### **2. Bylaws and Motion for Rezoning Application No. 00520 for 3031 Jackson Street**

**To:** Council **Date:** July 21, 2017  
**From:** Jonathan Tinney, Director, Sustainable Planning and Community Development  
**Subject:** Update Report for Rezoning Application No. 00520 and Development Permit with Variances Application No. 000475 for 3031 Jackson Street

Proposed 10 Townhouses for:

**Brian & Bev CANFIELD**  
at : 3031 Jackson Street, Victoria, BC

**P1**

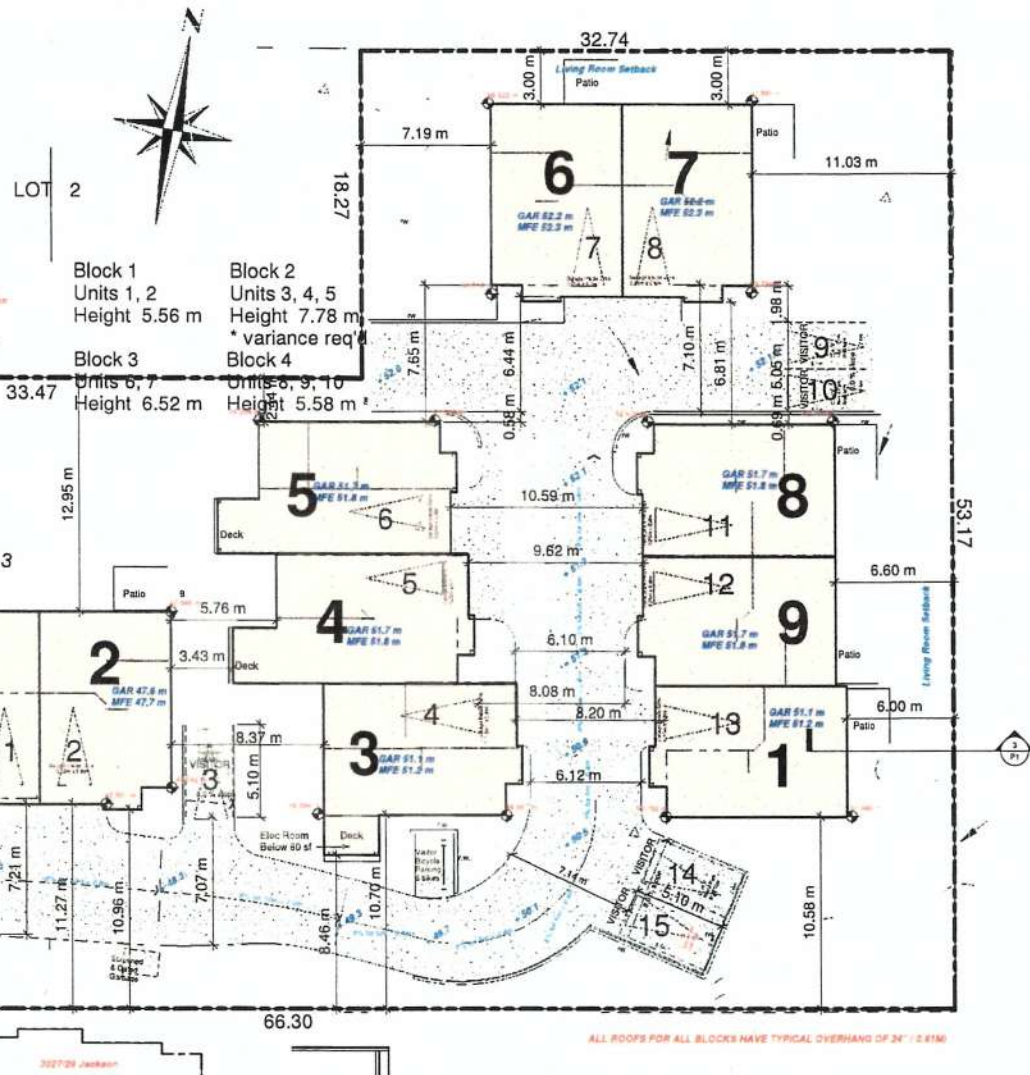
The purpose of this report is to inform Council that, in accordance with Council's motion of May 4, 2017 (see attached), staff have worked with the applicant to increase the rear yard setbacks for Units 8, 9 and 10 by 1.50m. This was accomplished by shifting the Attached Dwelling (Units

8, 9 and 10) further west and reducing the distance between the building and the shared driveway. Shifting the building has triggered an additional variance for building separation space between Units 7 and 8. The shift in building location has also changed the distance between buildings. These variances are supportable given the impact is internal to the site, sufficient distance is maintained between units to ensure liveability, and the siting of the buildings allows for retention of many of the mature trees on site. These new variances are shown in bold text in the amended motion above. The revised plans are attached for Council's consideration.

We have moved block 4 (units 8-10) away from property line by a further 1.5m. This distances us more from the fence line, and we have added a row of hedging along that entire lot line. This move was the most we could make without adversely affecting both vehicular movement on site but also separation between units within project.

Drive aisle was reduced to near bylaw minimums as any further move will force the shifting of other units and that would adversely affect and cause removal of two or more trees.

- ii. reduce front setback from 7.50m to 7.00m
  - iii. reduce the rear setback from 7.50m **to 6.00m (to Unit 10) and to 6.60m (to Units 8 and 10)**
  - iv. reduce the side setback (north) from 7.50m to 2.44m (to Unit 5) and to 3.00m (to Units 6 and 7) and to 7.19m (to Unit 6)

- v. reduce building separation space from 7.5m to 5.76m between Unit 2 and Unit 4; **and to 6.81m between Unit 7 and Unit 8**
  - vi. **reduce the minimum distance between Attached Dwellings from 10.00m to 6.81m between Unit 7 and Unit 8; and from 15.00m to 7.60m between Unit 3 and Unit 10; and from 10.00m to 3.43m between Unit 2 and Unit 4.**

**P4**

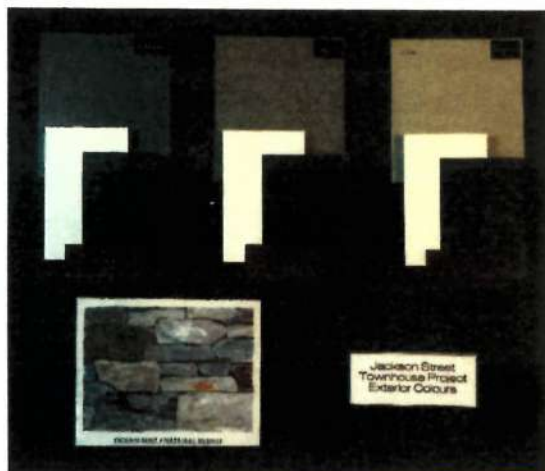
Revision A2: Recommendations from ADP

1. Top of S&S using formwork by 12" to cut the side windows
2. Bottom of S&S using lower replaces the belly band to maintain height, windows added or reduced to be larger

P5

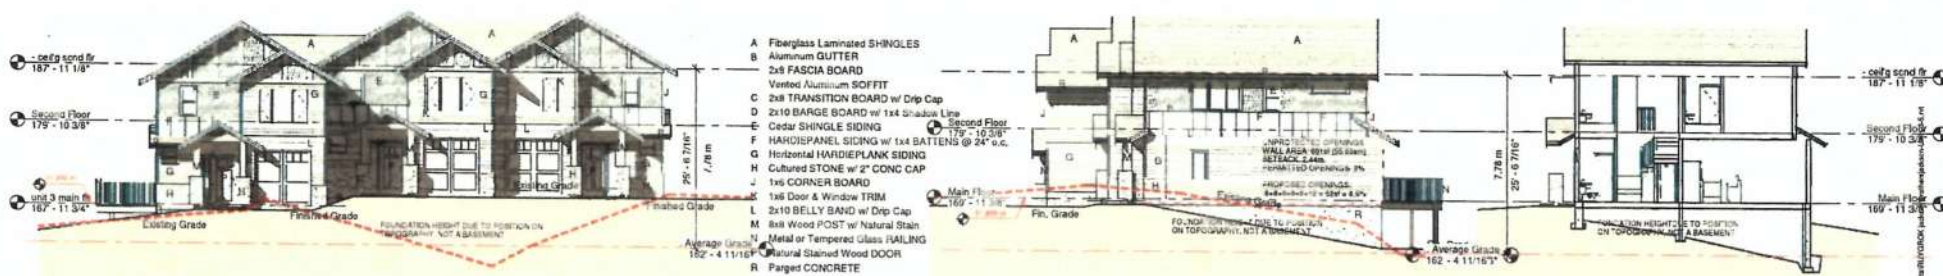
Revisions #2: Recommendations from ADP

1. Top of S&B siding lowered by 12" to permit taller windows
2. Bottom of S&B siding lower replaces the belly-band to maintain height and windows added/resized to be larger

**P6**

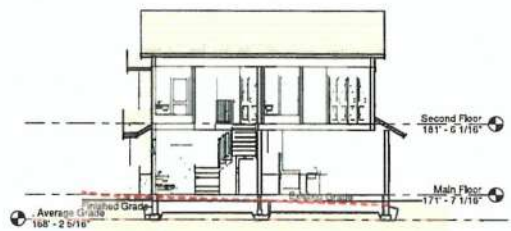
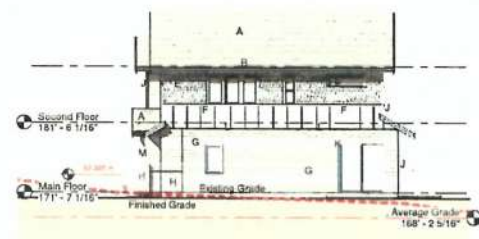
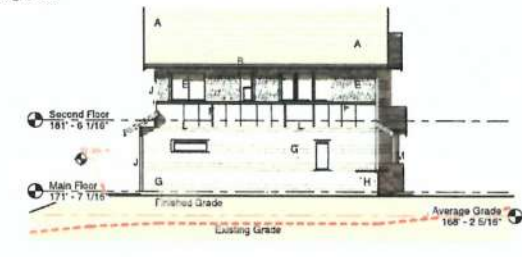
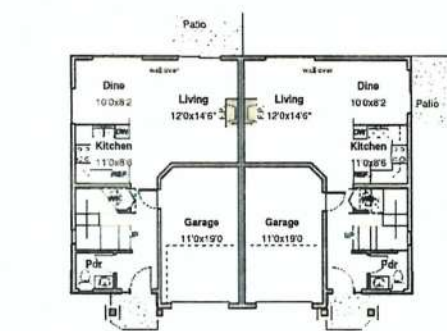
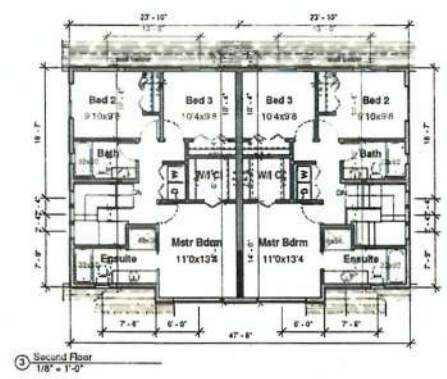
Revisions #2: Recommendations from ADP

1. Top of B&B siding lowered by 12" to permit taller windows
2. Bottom of B&B siding lower replaces the belly-band to maintain height and windows above resized to be larger

**P8**

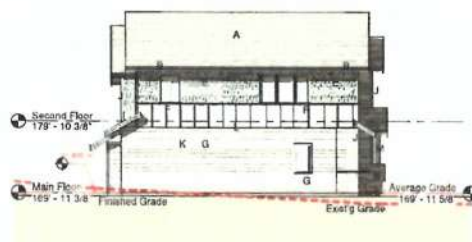
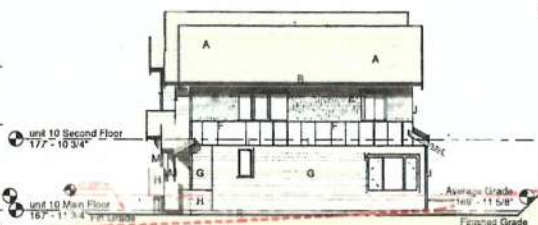
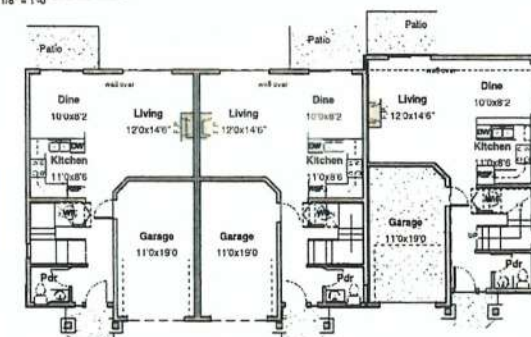
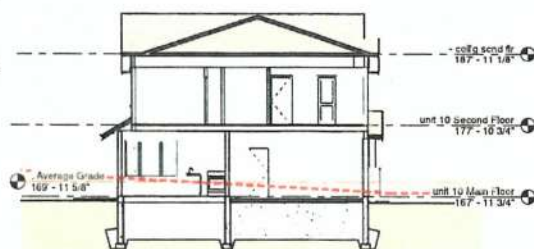
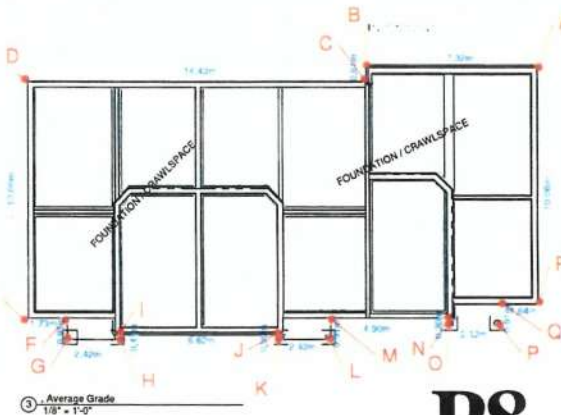
Revisions #2: Recommendations from ADP

1 Top of BAB siding lowered by 12" to permit taller windows.

2 Bottom of BAB siding lower replaces the bulky-band to maintain height and windows added/resized to be larger.

# 3031 JACKSON STREET TREE RETENTION & GRADING PLAN

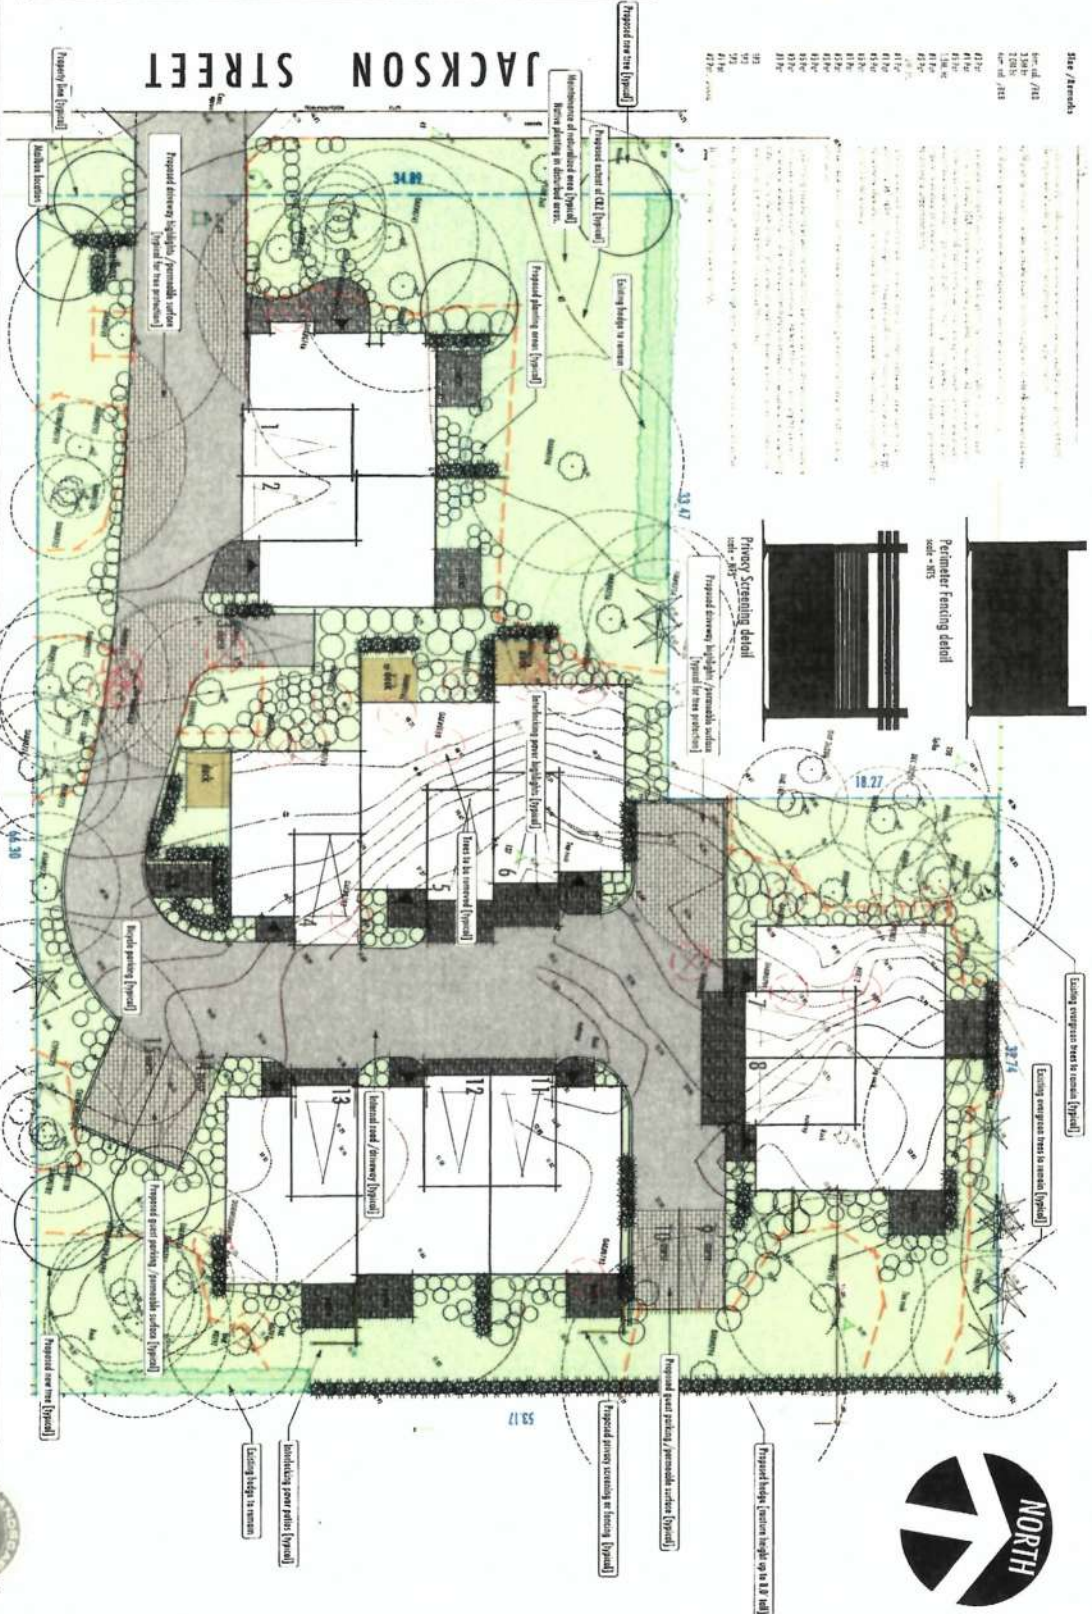
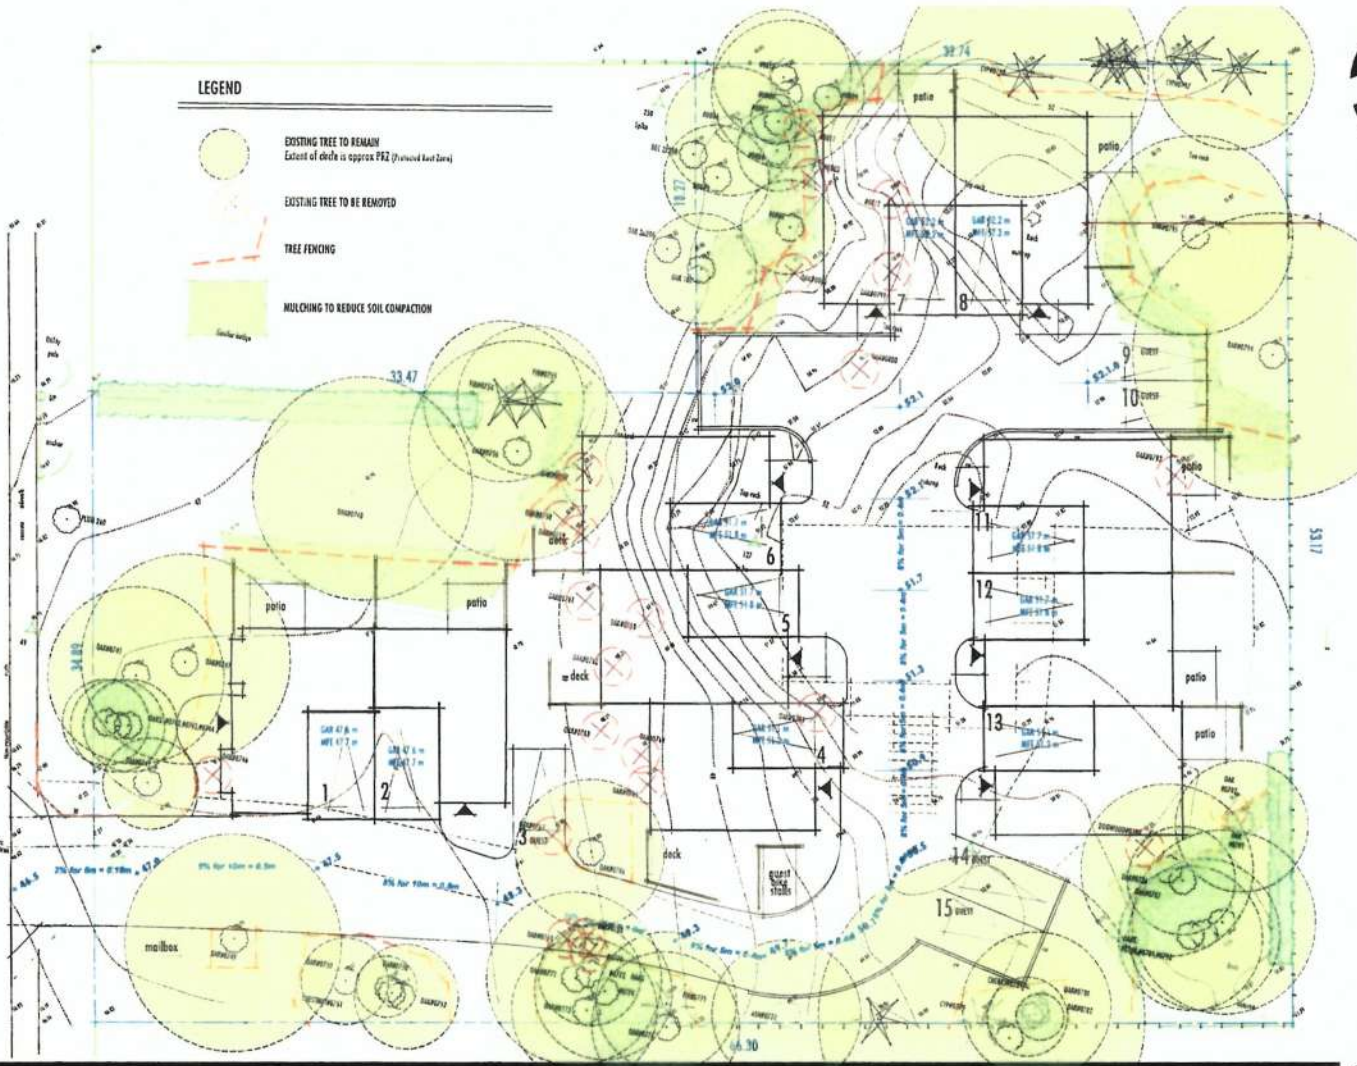
In addition to increasing the rear yard setback, the applicant has revised the landscape plan to extend the proposed cedar hedge along the east property line in order to mitigate potential privacy concerns and minimize potential overlook to the Wilderness Co-op site. There are no other changes to the proposal.
